APPENDIX C
AREA WALK-BY CHECKLISTS (AWCs)

Area Walk-By Checklist (AWC)

Room 105 Floor El. 545 Bldg. AUXB

Photo 2
Missing Nuts on Cover of E31-4

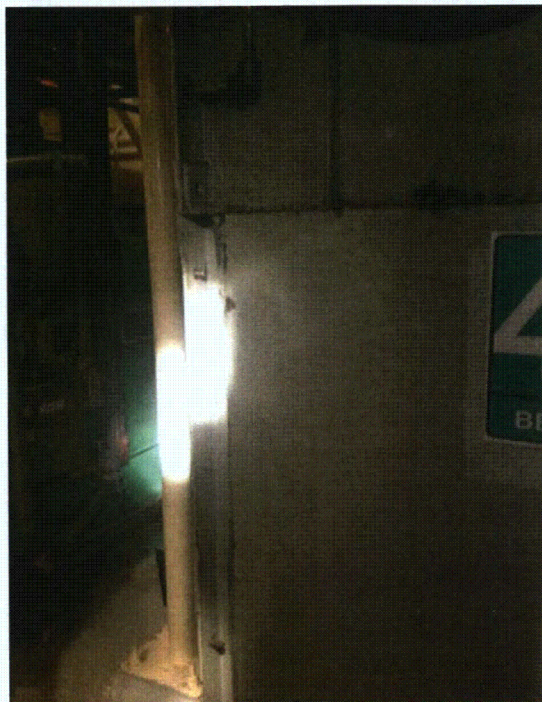
Anchorage for cover plate of E31-4 does not have nuts, see Photo 2. Concern has been judged not to represent an adverse condition regarding the component's seismic performance.

Photo 3
Temporary Scaffolding Restrained

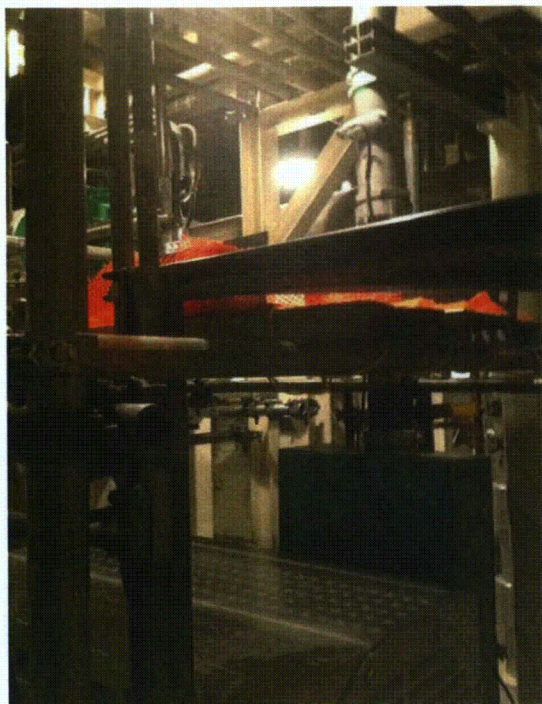
Temporary scaffolding in area appears to be adequately restrained. See Photo 3.

Photo 2
Unrestrained Dolly in Area

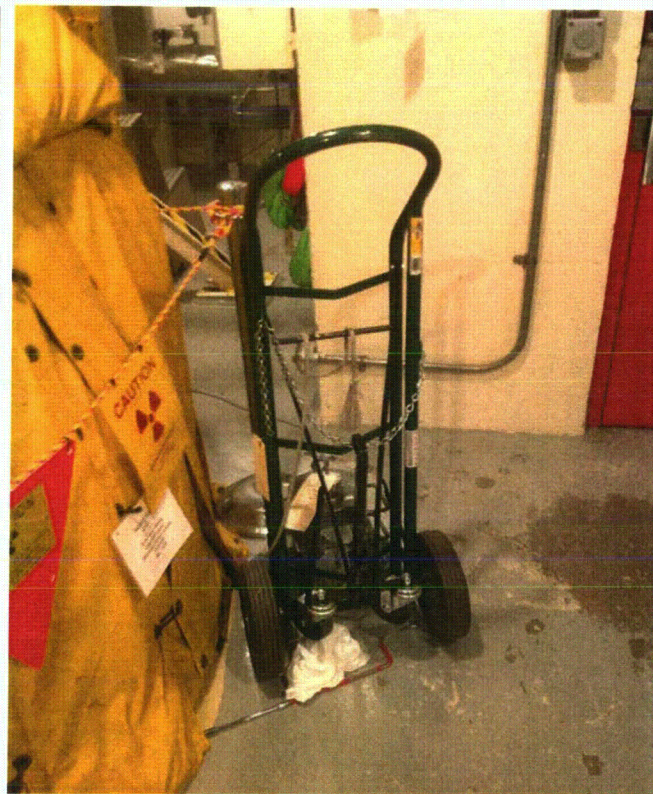
A dolly was found unrestrained in the area. Since the dolly had restraining chains on it, it was judged that it is temporarily located at the position found in the room and will be returned to its storage location and tied when work is done. Also, no sensitive equipment found in the vicinity of this dolly.

Photo 1
Dolly Not Restrained

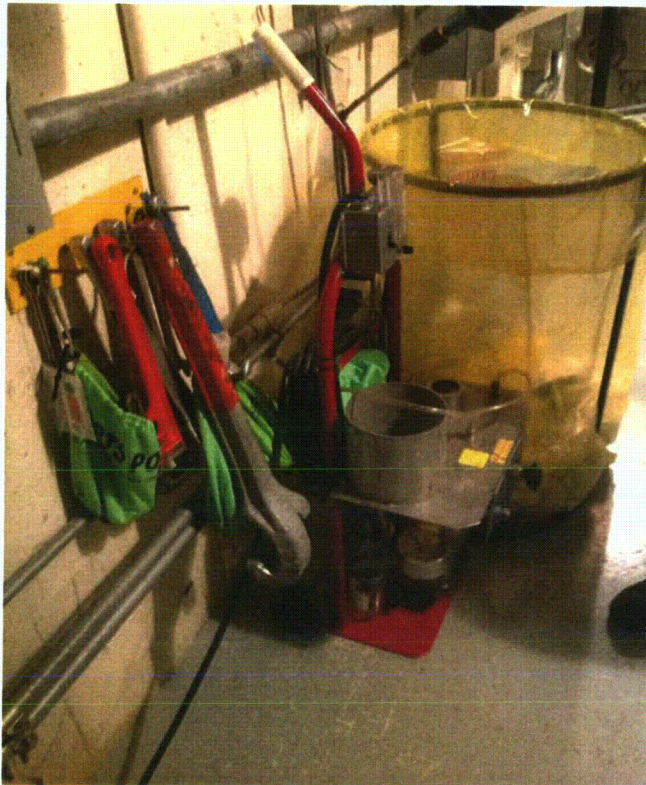
RP cart and dolly not restrained.

In a subsequent visit to his area on the next day, it was observed that this cart was properly restrained.
